Dart18 Class Rule Changes Agreed by the IDRC September 2017
For general circulation.

Jib strop to jib clew amendment.

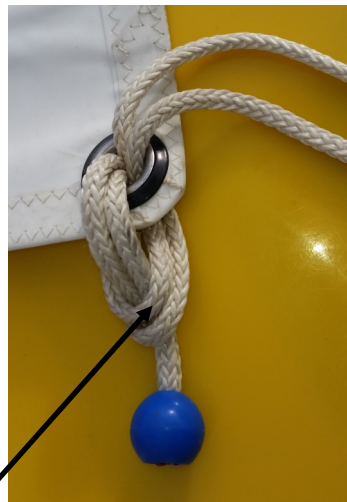
The snap hook DS404 can now be replaced with a ball and short length of line. The length of the jib strop is unchanged from its original overall length.

Overall length of trapeze adjuster amendment.

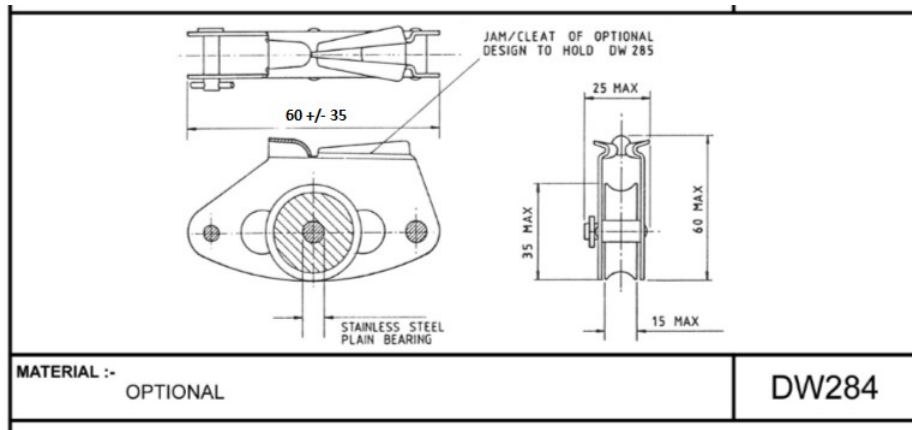
The overall length of DW284 has been adjusted such that the maximum length is 95mm.

Jib stop diameter amendment.

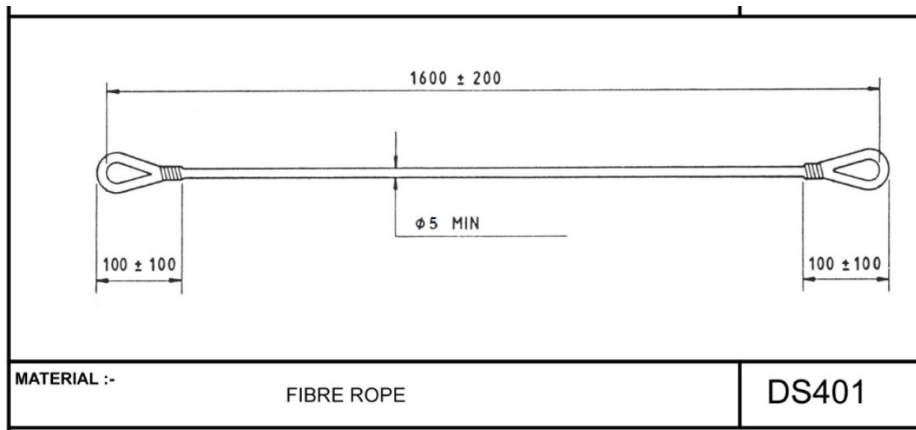
Minimum diameter of the jib stop is reduced to 5mm.

Trampoline pocket amendment.

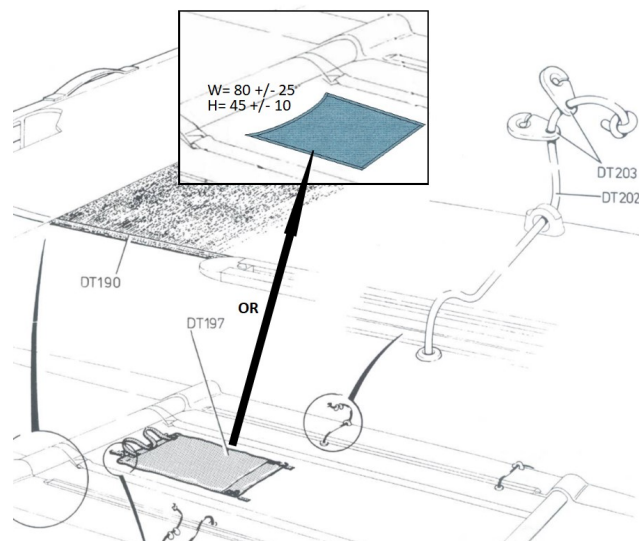
The Satchel DT197 can be replaced with a pocket sewn to the trampoline.
